Garlick's Arch

Regulation 25 and Clarifications Report

Guildford Borough Council

REVIEW OF LVIA ADDENDUM
SUBMITTED AS PART OF SUPPLEMENTARY ENVIRONMENTAL STATEMENT

COMPARATIVE PARAMETER PLANS

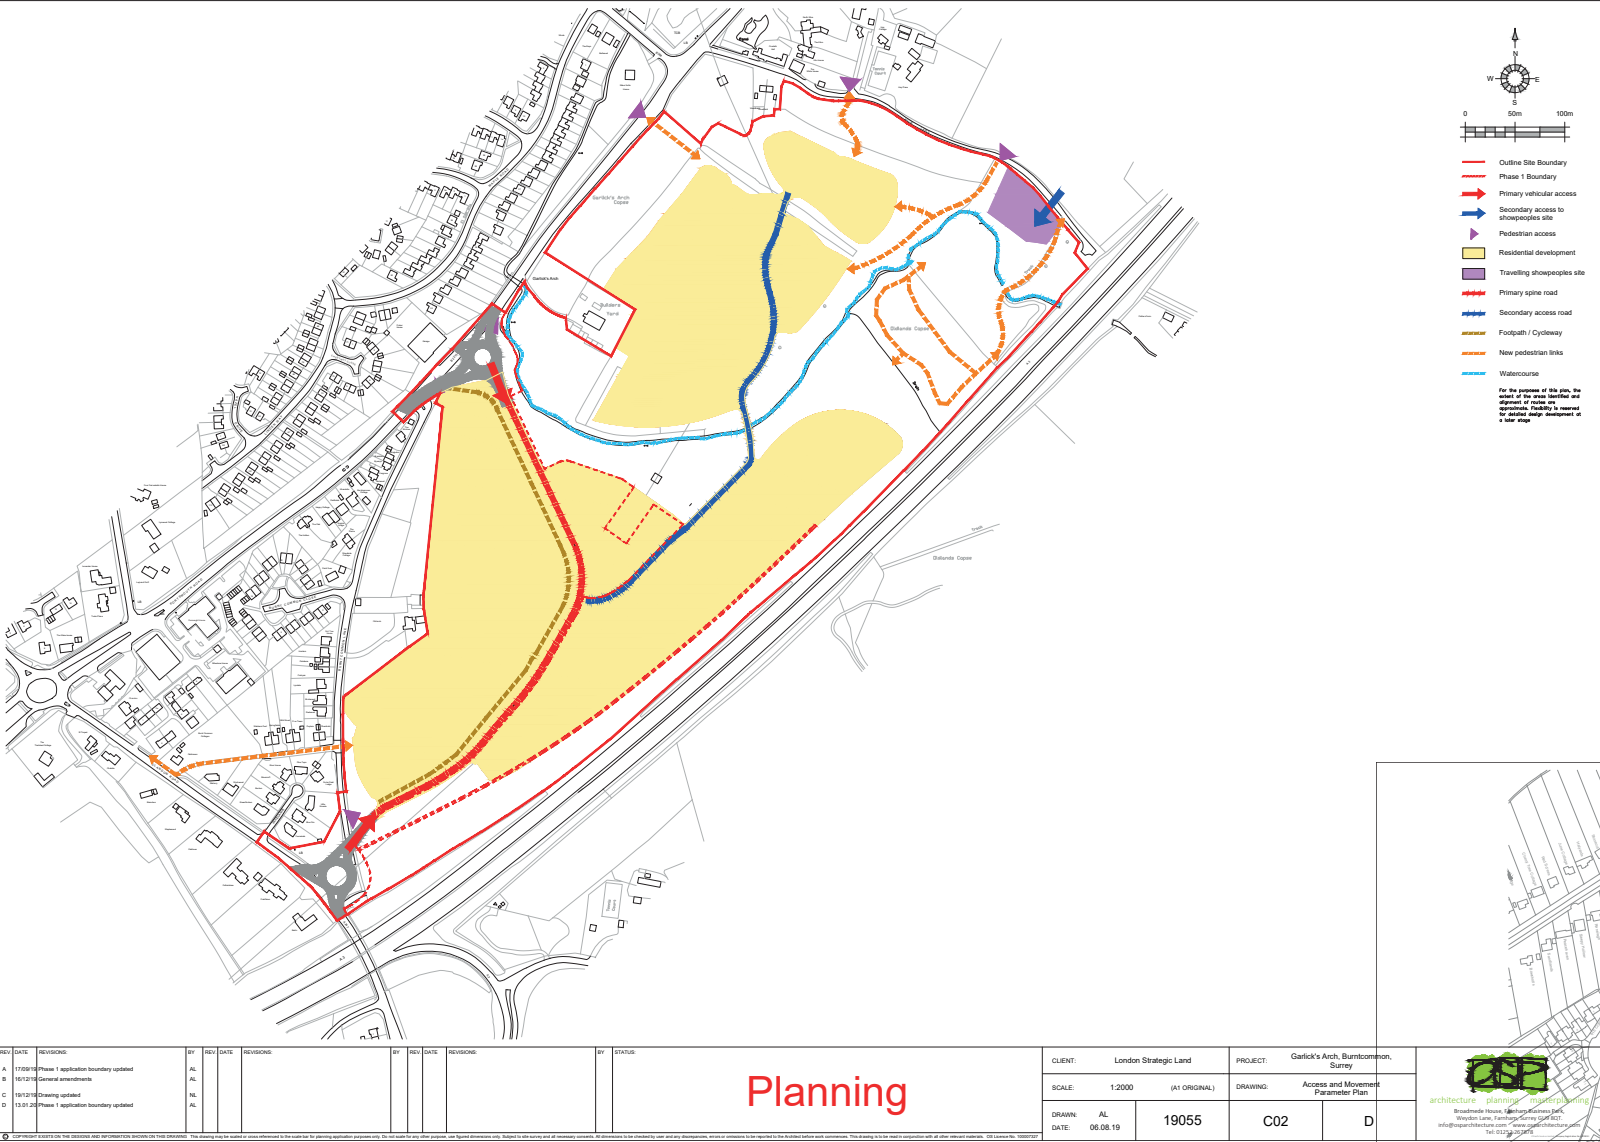
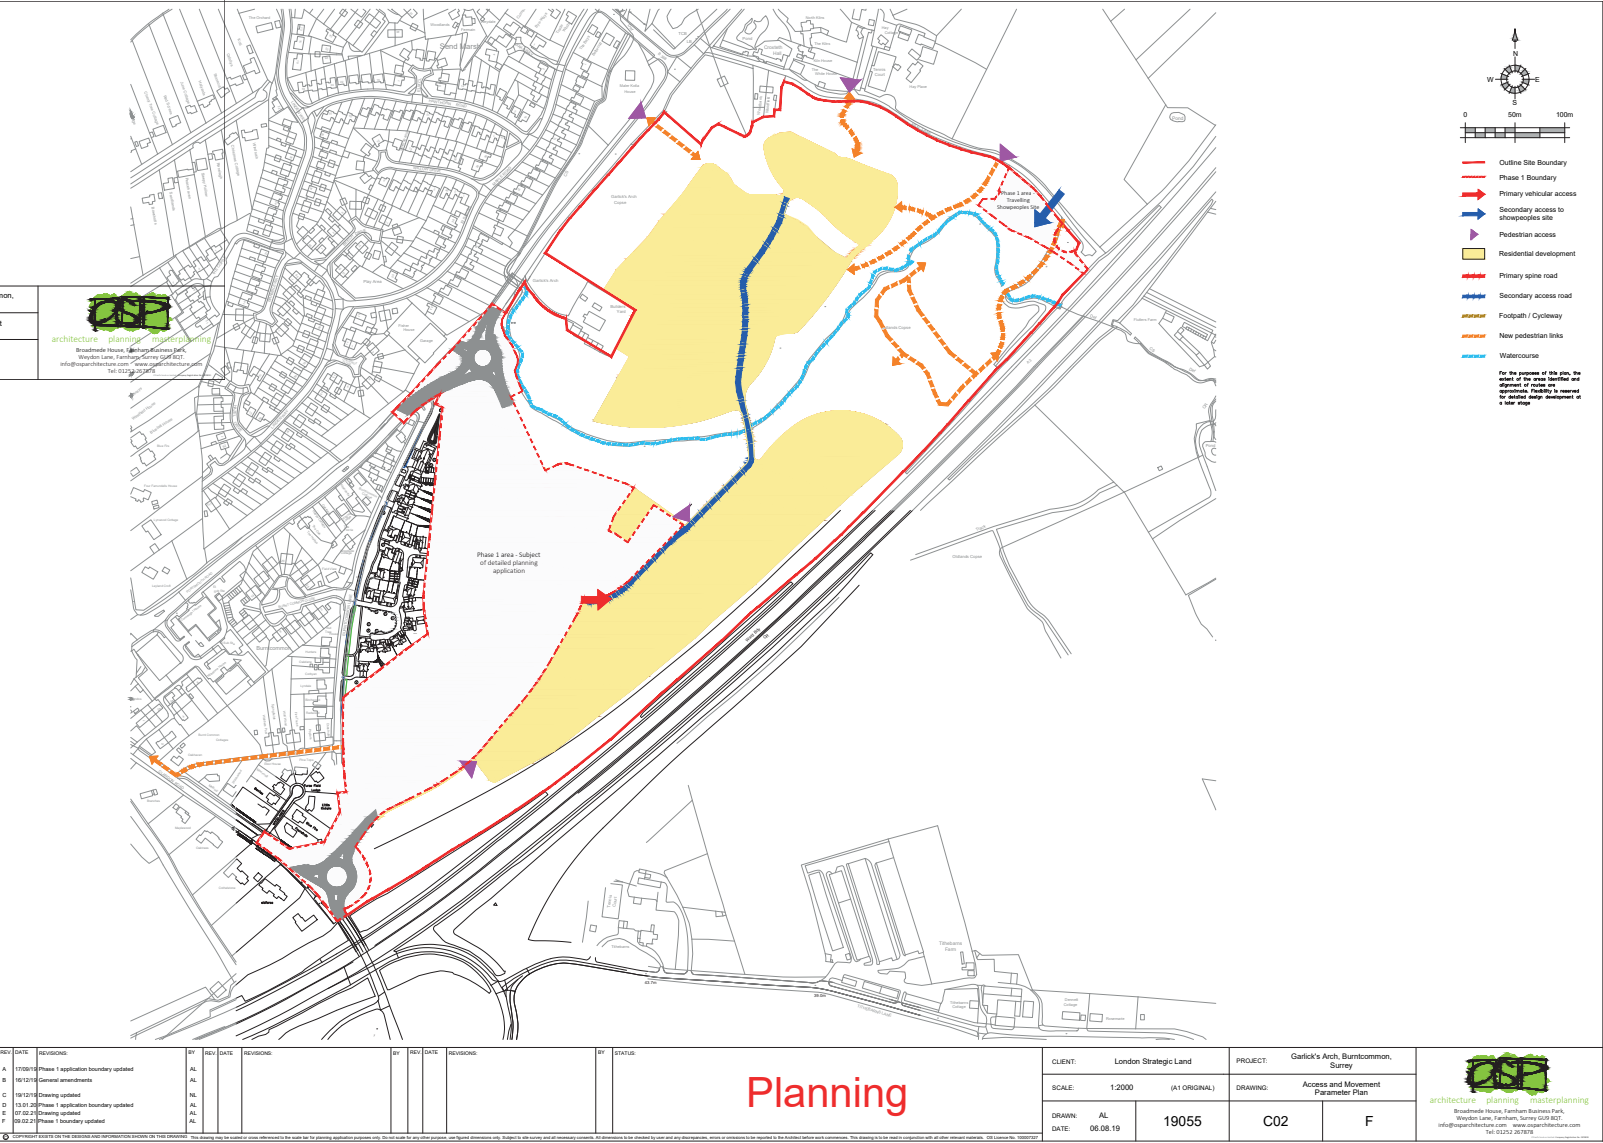
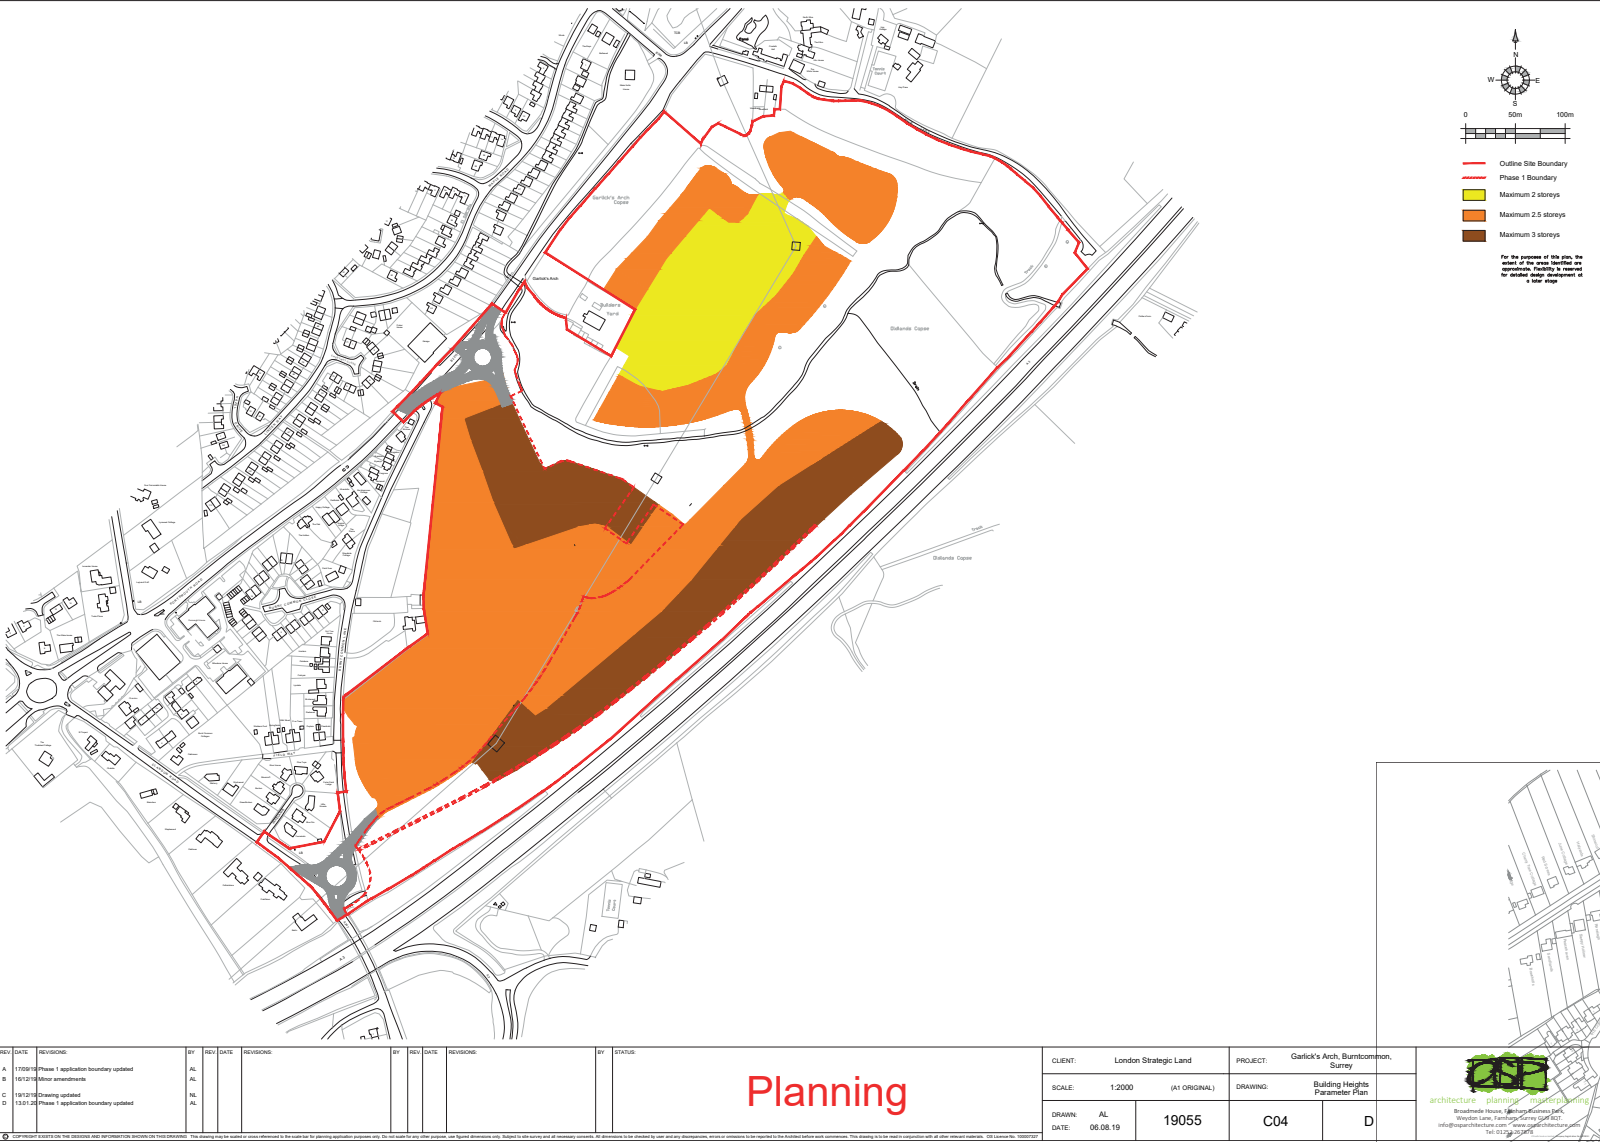
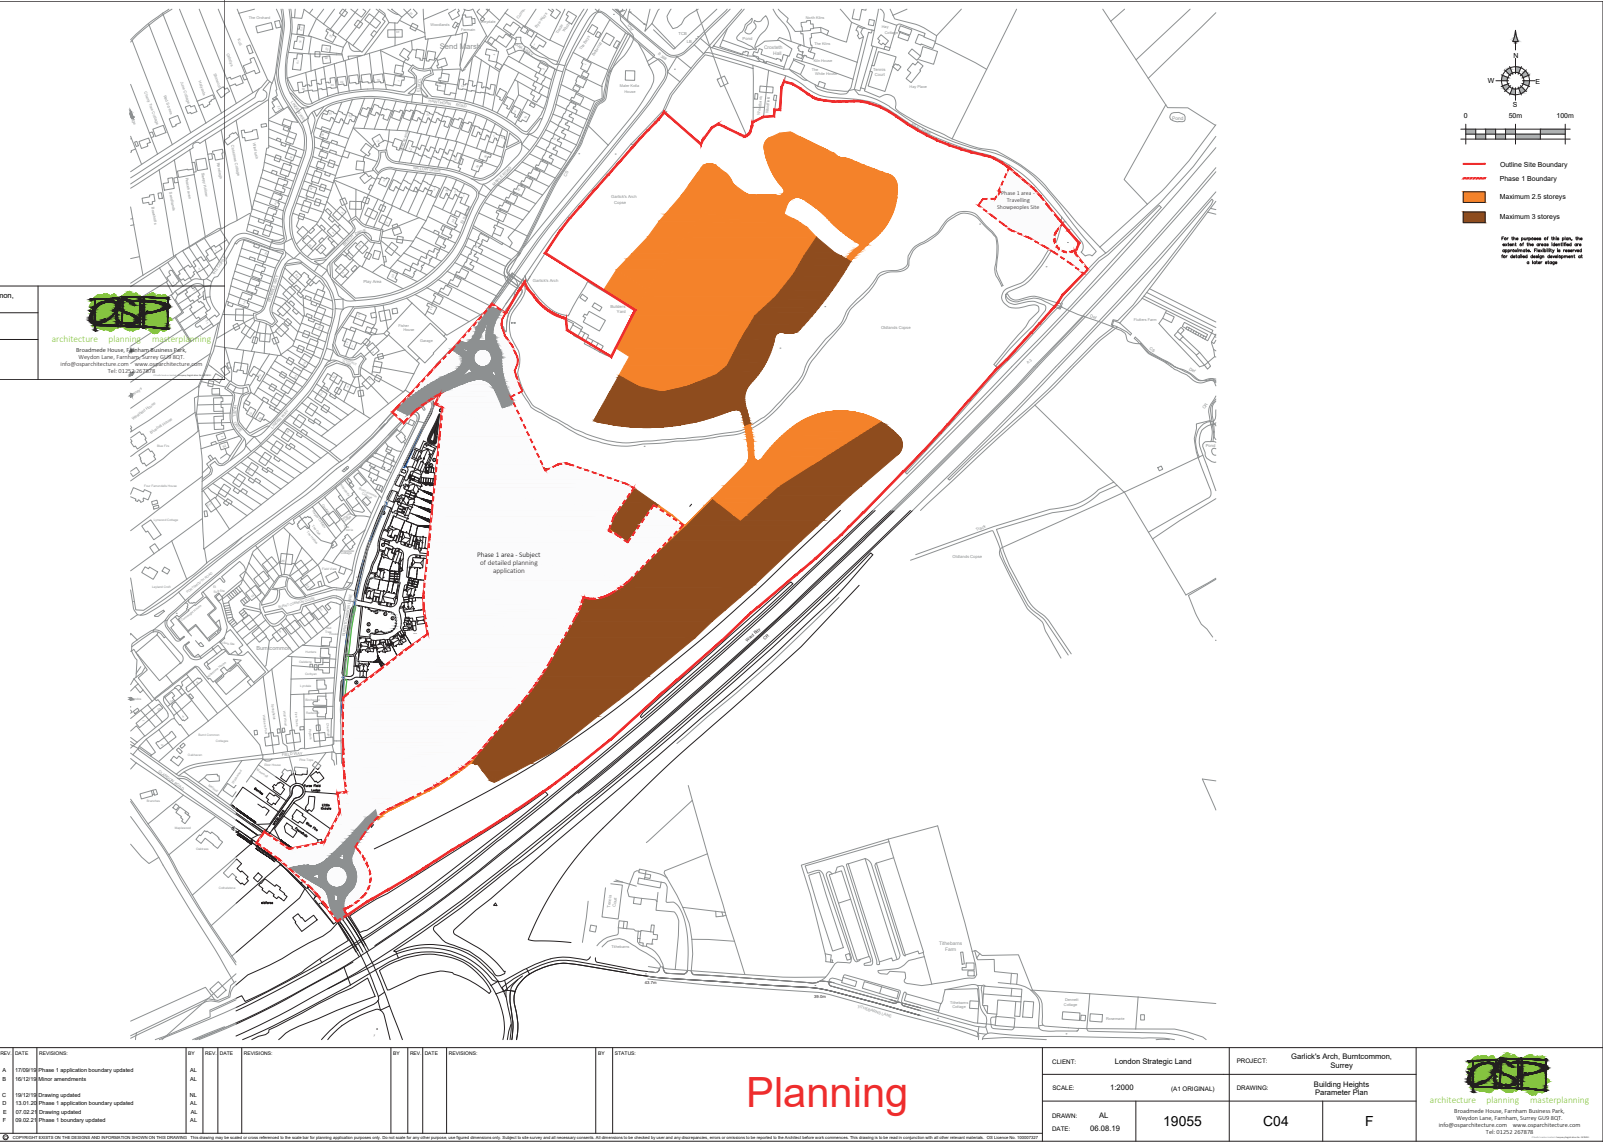
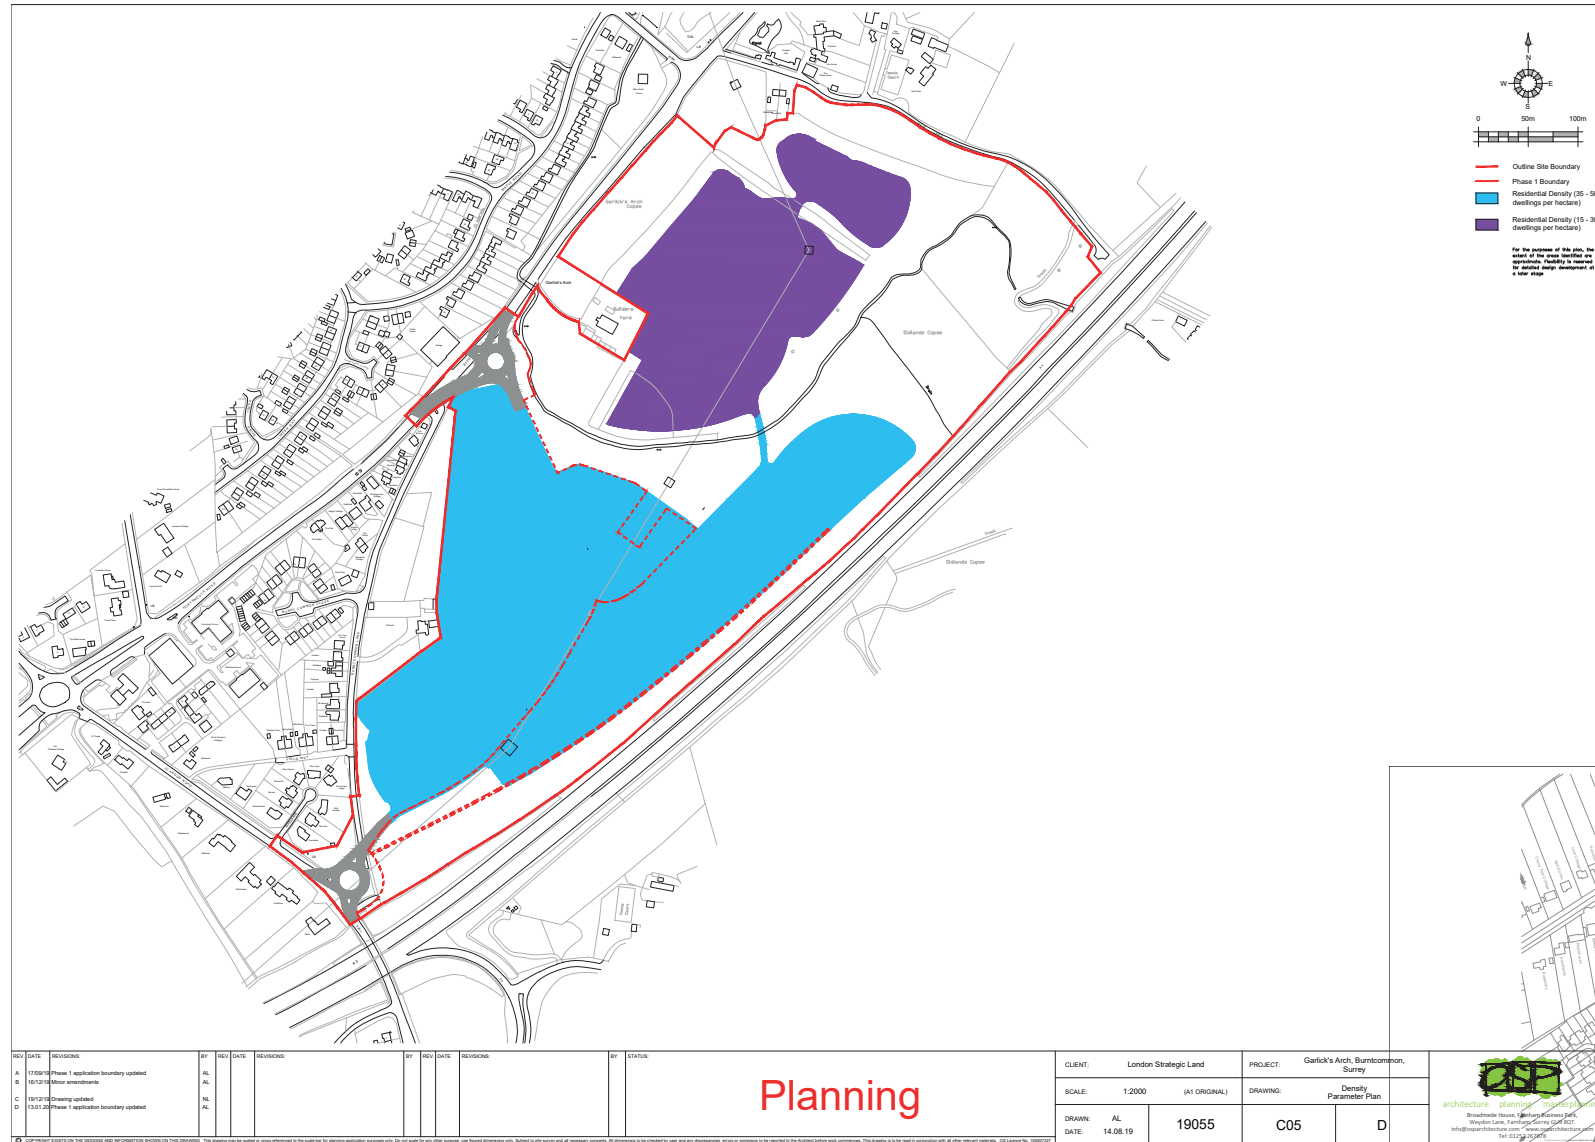
- 3.3.1. Land Use Parameter Plan**
- Phase one is subject to detailed planning application and is not shown on the 2021 Land Use Parameter Plan.
 - The dimensions of the traveling showpeoples' site have changed. Area appears to have increased in size.

- Open space layout on site has been altered.
- 3.3.2. Access and Movement Parameter Plan**
- Primary vehicular access has changed location, possibly as a result of phase two not being shown on the plan.

- 3.3.3. Landscape Parameter Plan**
- Swales and SuDS basins are not shown on the 2021 parameter plan.
 - Modifications to play strategy are observed.
 - Open space layout alterations are observed.

- 3.3.4. Building Heights Parameter Plan**
- Area in centre of site is changed from maximum two storeys to maximum 2.5 storeys.
 - Phase one is subject to detailed planning application and is not shown on the 2021 plan.

- The area of three storey maximum height structures on the southern boundary, with frontage on the A3, has increased in size.

- Phase one is subject to detailed planning application and is not shown on the 2021 plan.
